LINCOLN CITY/LANCASTER COUNTY PLANNING STAFF REPORT

for February 15, 2006 PLANNING COMMISSION MEETING

- PROJECT #:** Preliminary Plat #04030
- PROPOSAL:** To create 151 single-family residential lots.
- LOCATION:** South 84th Street and Yankee Hill Road.
- WAIVER REQUESTS:**

JENSEN PARK ESTATES
PRELIMINARY PLAT

JENSEN PARK ESTATES
PRELIMINARY PLAT

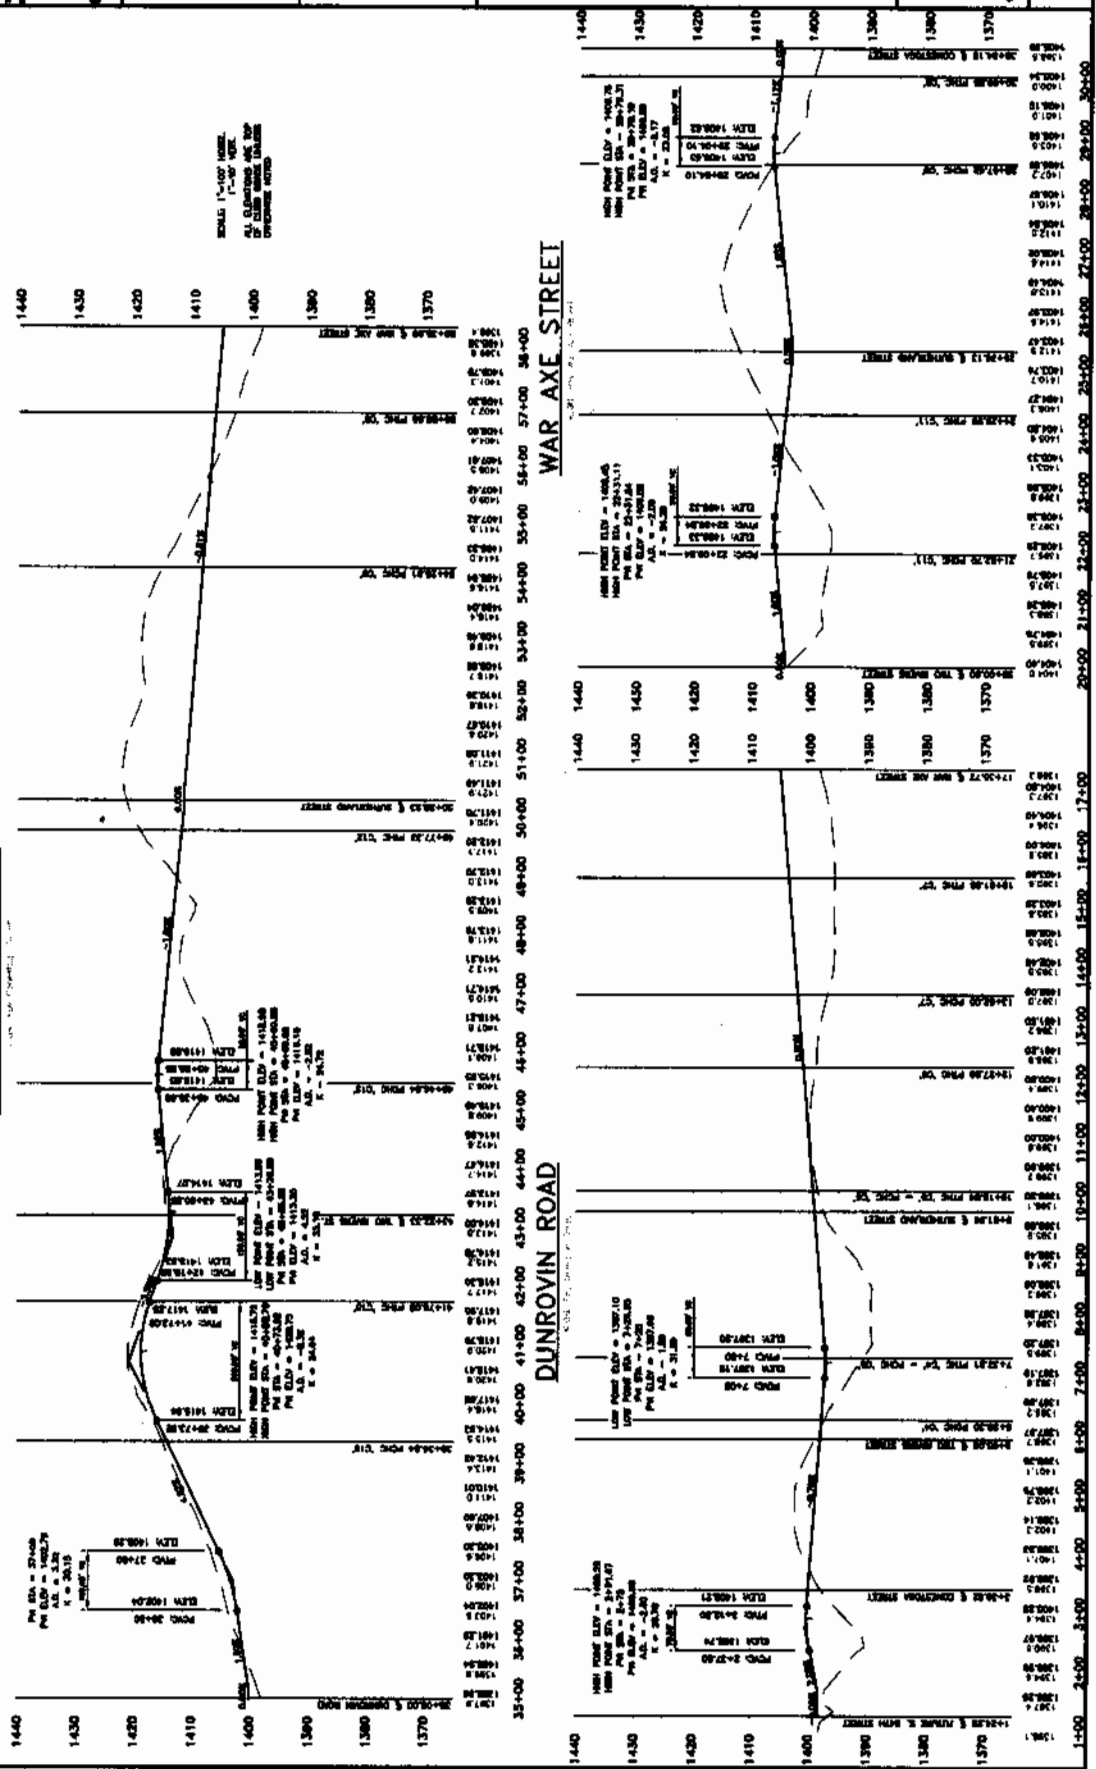
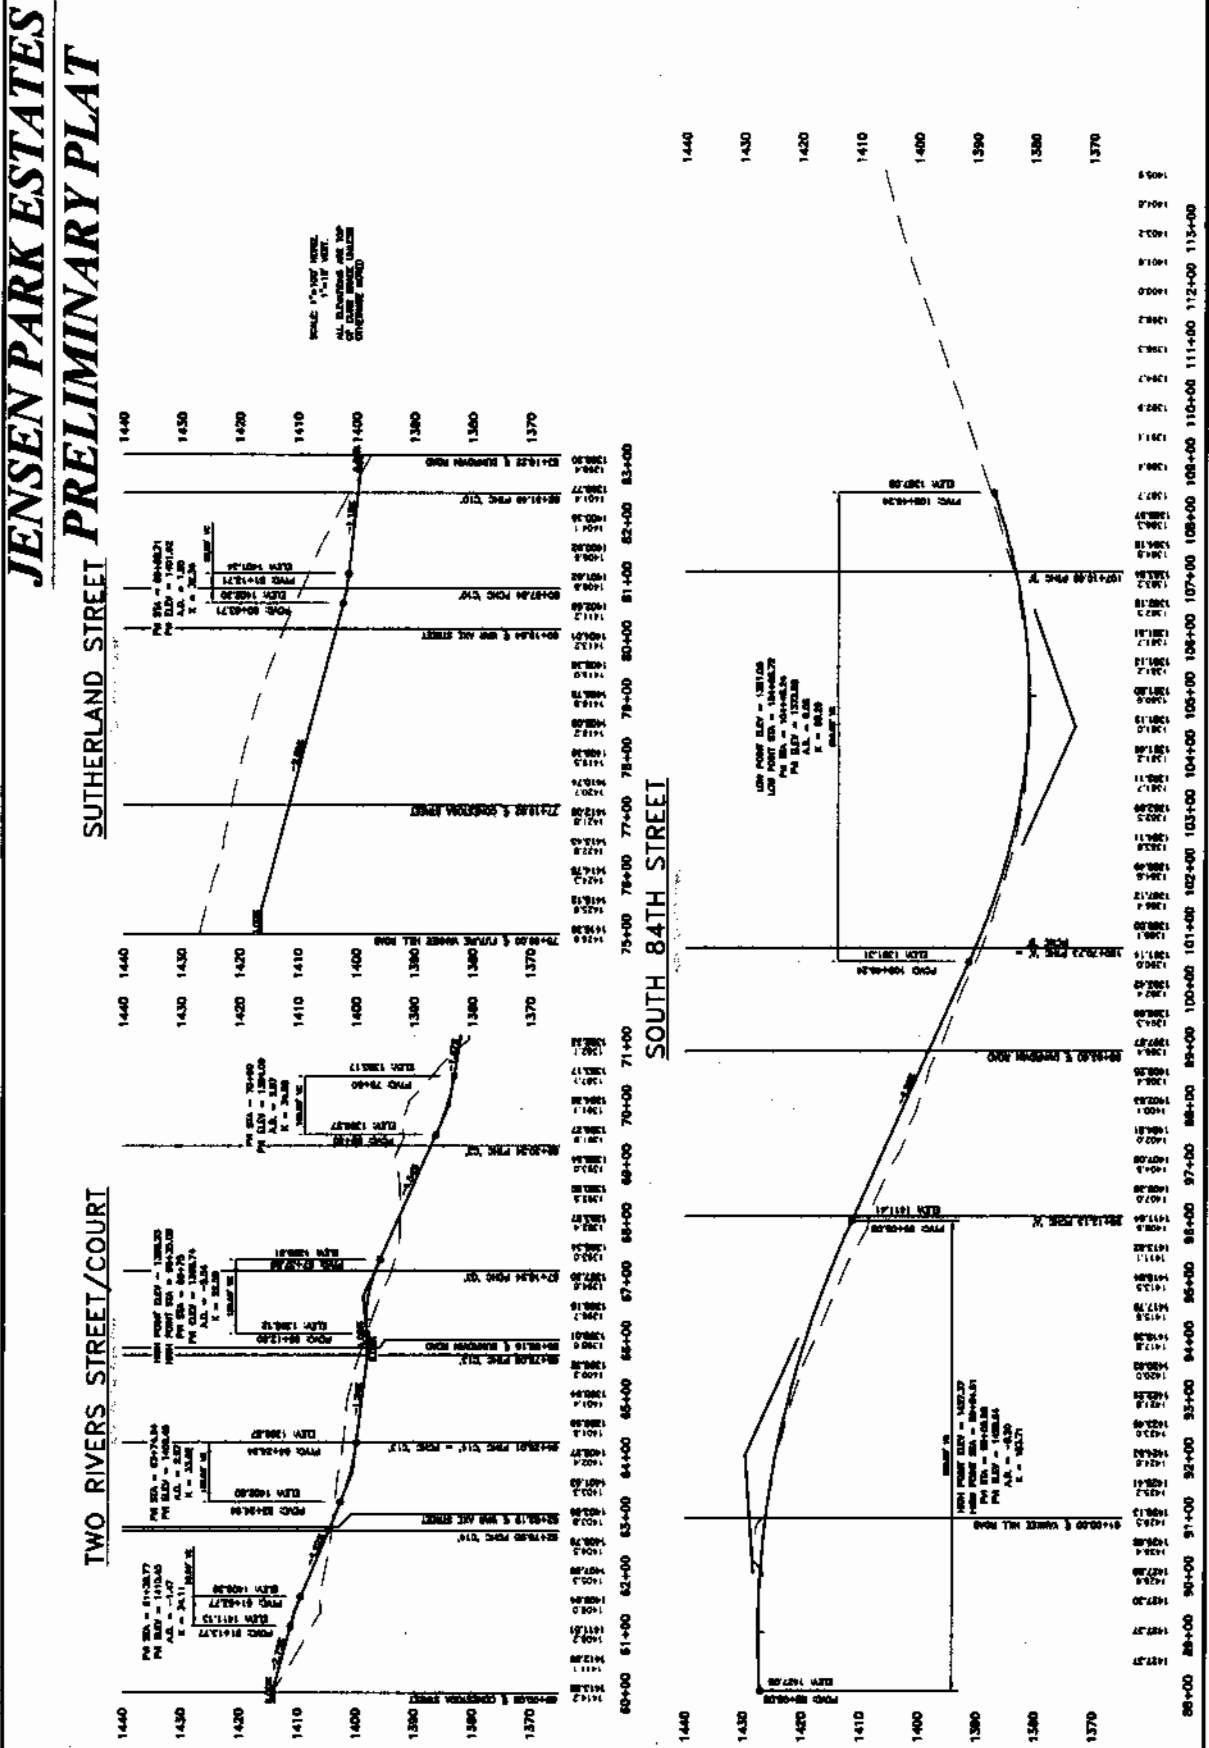
- 1.1 Revise the preliminary plat as follows:
 - 1.1.1 Show a street connection to Lot 111, unless the subdivider's waiver request is approved by the City Council.

- 1.1.2 Delete General Site Notes 10, 11, 15, 16, and 17 which restate applicable requirements and are redundant.
 - 1.1.3 Delete Site Specific Note 9 which precludes sidewalks along both sides of Yankee Hill Road and South 84th Street, or restate it to say that this project is only responsible for the sidewalks along the east side of South 84th Street and the north side of Yankee Hill Road.

- 1.1.4 Delete the note "10' Right-Turn Easement."
 - 1.1.5 Show the required screening along arterial street and railroads.
 - 1.1.6 Rename the north-south portion of Conestoga Street closest to South 84th Street.

- 1.1.7 Make revisions to the satisfaction of Public Works and Utilities.
 - 1.1.8 Show easements as required by L.E.S.
 - 1.1.9 Show all lots meeting the 110' minimum lot depth requirement, unless the subdivider's waiver request is approved by the City Council.

Comments: The north-south part of Conestoga Street closest to South 84th Street should be a different name than the east-west Conestoga Street. It is a little lengthy to have the same name. The address numbering of this street and the streets around them would be accurately defined.

☐ (2.1) ☐ The single 6" water main at connection Dunrovin Road to the proposed 24" in water main in 84th Street is satisfactory to Public Works. However, since the 24" water main in 84th Street is an impact fee facility and would be eligible for reimbursement, the 24" needs to be shown extended to the intersection of 84th and Yankee Hill Road.

☐ (3.1) ☐ The grading and drainage plan is unsatisfactory. As stated in the previous report, there is a significant area south of Yankee Hill Road that drains to this site via a culvert under Yankee Hill Road. The proposed storm sewer design does not show any storm sewer to connect to this culvert indicating that the storm water from the area to the south will be diverted through the future Yankee Hill storm sewer system to the railroad ditch to the north and east of this plat. This will add additional costs to the Yankee Hill project that would not otherwise be necessary. The grading and drainage plan needs to be revised to show storm sewer available to account for this drainage area. The detention calculations will need to be revised to account for this change.

☐ (3.2) ☐ Although the minimum opening elevations shown for lots in Block 4 are adequate for the 100 year elevation indicated in the detention calculations, the low elevation in the Dunrovin Road cross-section is nearly 1' higher. Since it does not appear that any lots will be affected, the minimum openings for these lots should be revised to match the low point in Dunrovin Road.

☐ (3.4) ☐ The grading for the future 84th Street improvements need to be shown on the grading plan to ensure that the proposed site grading will work with the future roadway grading. Also, design on 84th has not started yet. The 84th Street profile and adjacent grading on this plat may need to be revised when a final profile is set for 84th Street.

(4.1) A street connection needs to be shown extending to Lot 77 to the north of this plat. The submittal letter references the existence of wetlands as justification for not making this connection. Wetland mitigation is taking place in a number of areas throughout the plat and this area would be allowed to be mitigated for. Also, the street connection will provide access to allow Lot 77 to develop in the future and would eliminate the need to create an additional intersection with South 84th Street. Lot 77's proximity to the railroad crossing would be a good location for an intersection.

(4.2) A waiver to the subdivision ordinance requirements for curb and gutter needs to be requested for 84th Street. If a curb and gutter section is waived, this developer would be responsible for constructing temporary turn lanes at all street connections to Yankee Hill and 84th Street.

(4.3) The submittal letter states that the entire plat is to be developed at the same time. Prior to the approval of the final plat, two of the four lanes of Yankee Hill Road including the full intersection and left turn lane at Yankee Hill and Sutherland Street will need to be constructed to urban standards from 84th Street to the existing stub of 91st Street.

Per our discussions right of way for the right turn lanes in Yankee Hill Road needs to be clearly indicated as dedicated right of way. The additional 10' is shown on the plat as if it is dedicated, but a note and arrow indicates a turn lane easement. We request that the note be removed.
